ATTACHMENT C – PROPOSED RULE CHANGES IN MARK-UP – AUSWIND DETAILED RESPONSE.

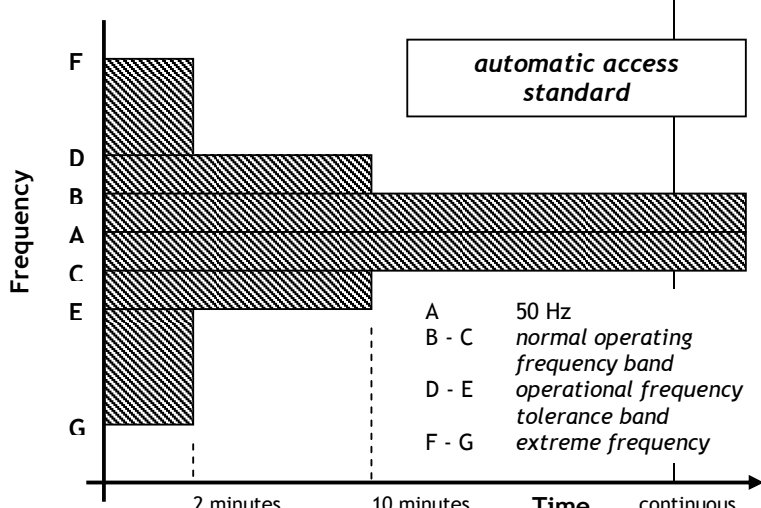
Affected clause	Clause with proposed amendments	Reason	Auswind Comments
S5.2.5.1	<p>Reactive power capability</p> <p>For the purpose of this clause S5.2.5.1:</p> <p>‘rated active power output’ means the ‘Rated MW (Generated)’ (as defined in schedule 5.5.1) for the relevant synchronous generating unit; and</p> <p>‘nominal voltage’ means the ‘Nominal voltage at connection to Network’ (as defined in schedule 5.5.1) at the connection point for the relevant synchronous generating unit.</p> <p>(a) Automatic access standard: Each synchronous generating unit or generating system, while operating at any level of active power output and any voltage at the connection point within the limits established under clause S5.1a.4 without a contingency event, must be capable of(1)—supplying and capable of absorbing, continuously at its connection point an amount of reactive power of at least the amount equal to the product of the rated active power output of the generating unit or generating system at nominal voltage and 0.395(2)—absorbing at its connection point an amount of reactive power of at least the amount that would be absorbed equal to the product of the rated active power output of the generating unit at nominal voltage and 0.395.</p> <p>(b) Minimum access standard: No capability is requiredment to supply or absorb reactive power at the connection point.</p> <p>(c) When negotiating an access standard tThe Generator and the Network Service Provider:</p> <p>(1) may in accordance with clause 5.3.4A of the Rules, negotiate a must, subject to any agreement under clause S5.2.5.1(d)(4), ensure that the reactive power capability of the generating unit</p>	<p>The definition of rated active power has been replaced to remove reference to Schedule 5.5.1, and remove technology-specific wording.</p> <p>Reference to S5.5.1 has been removed because this schedule is to be replaced and the replacement documents may no longer contain that reference.</p>	<p>Comments to be taken into account.</p> <p>Agreed but not at any voltage level as identified in S5.2.5.1(a).</p> <p>Requirements at the connection point are all that should be required for generating systems.</p> <p>Generators should also be able to negotiate the point at which the requirement is met (connection point or</p>

Affected clause	Clause with proposed amendments	Reason	Auswind Comments
	<p><u>or generating system</u> is sufficient to ensure that all relevant <u>system standards</u> are met <u>before and after</u> under system normal and credible contingency events operating conditions <u>under normal and planned outage operating conditions of the power system</u>, taking into account at least existing and <u>considered projects</u>;</p> <p>(2) <u>may negotiate either a range of reactive power absorption and supply, or a range of power factor, at the connection point, within which the plant must be operated; and;</u></p> <p>(3) <u>may negotiate a limit that describes how the reactive power capability varies as a function of active power output</u> active power output <u>due to a design characteristic of the plant.</u></p> <p>(d) The Generator may reach a commercial arrangement with the Network Service Provider or a Registered Participant for the provision of reactive power capability sufficient to ensure the Generator's obligation under this clause is met. <u>If the proposed generating system is not capable of the level of performance established under clause S5.2.5.1(c)(1), the Network Service Provider may:</u></p> <p>(1) <u>require the Generator to pay compensation to the Network Service Provider for the provision of the deficit of reactive power (supply and absorption) from within the network;</u></p> <p>(2) <u>allow the Generator to install additional equipment connecting at the generating system's connection point or another location, to provide the deficit of reactive power (supply and absorption), which equipment is deemed to be part of the generating system;</u></p>	<p>Sub-clauses (2) and (3) specify greater details about what can be negotiated and this will mean that alternative methods of providing reactive power capability more economically will be explicitly available.</p> <p>The automatic access standard has been extended to apply to any technology, and not just to synchronous plant, and to apply to generating systems.</p> <p>The basis of negotiation has been amended to clarify it, and provide flexibility in the way that reactive power is specified.</p>	<p>machine terminals)</p>

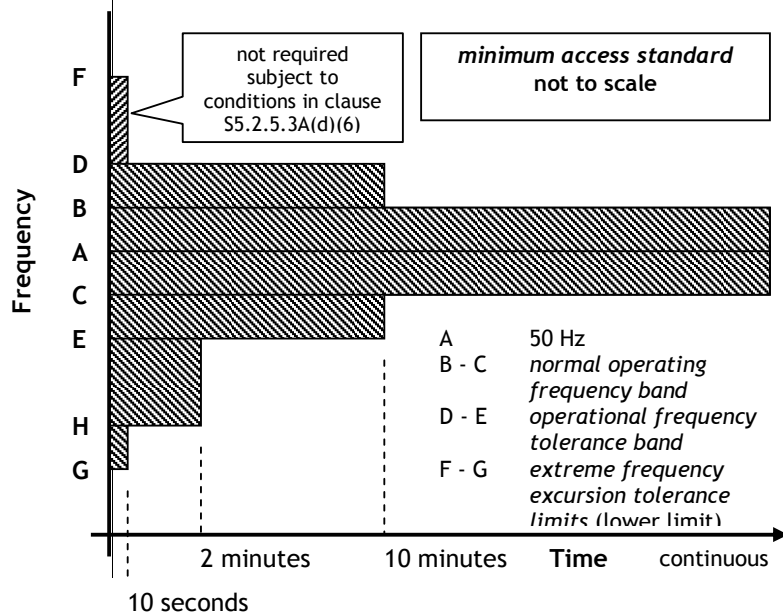
S5.2.5.2	<p>Quality of electricity generated</p> <p>(a) <i>Automatic access standard:</i></p> <p>(1) The <i>plant standard</i> in accordance with clause S5.2.5.2(e); or</p> <p>(2) Each <i>generating system</i> unit, when generating must generate a constant voltage level, and when not generating, must not produce at any of its <i>connection points for generation</i> draw electricity, with:</p>	<p>To allow for the possibility that the generating system has multiple connection points. The words ‘for generation’ are necessary to distinguish between auxiliary supply connection points and generation connection points.</p>	<p>Agree</p>

Affected clause	Clause with proposed amendments	Reason	Auswind Comments
	<p>(i) voltage fluctuation equal to or less greater than the limits determined allocated by the <i>Network Service Provider</i> in accordance with under clause S5.1.5(a); and</p> <p>(ii) harmonic voltage distortion equal to or less greater than the emission limits determined specified by a <i>plant standard</i> under clause S5.2.5.2(d) or allocated by the <i>Network Service Provider</i> in accordance with under clause S5.1.6(a); and</p> <p>(iii) voltage unbalance equal to or less greater than the limits allocated by the <i>Network Service Provider</i> in accordance with clause S5.1.7(c)(1).</p> <p>(b) <u>Minimum access standard: Each generating unit system, when generating and when not generating, must not produce at any of its connection points for generation:</u></p> <p>(1) <u>must generate a constant voltage fluctuations greater than limits determined under clause S5.1.5(b); level with balanced phase voltages and</u></p> <p>(2) <u>harmonic voltage distortion equal to or less more than the lesser of the</u> emission limits determined by the relevant <i>Network Service Provider</i> in accordance with under clauses S5.1.5(b) and S5.1.6(b) and clause S5.1a.7 of the system standards specified by a <i>plant standard</i> under clause S5.2.5.2(d); and</p> <p>(3) <u>voltage unbalance more than limits determined under clause S5.1.7(c)(2).</u></p> <p><u>(c) The access standard negotiated under clause S5.2.5.2</u></p>	<p>The AS 1359.101 refers to a superseded version of IEC 60034-1. Amendment is to include current version of IEC 60034-1</p>
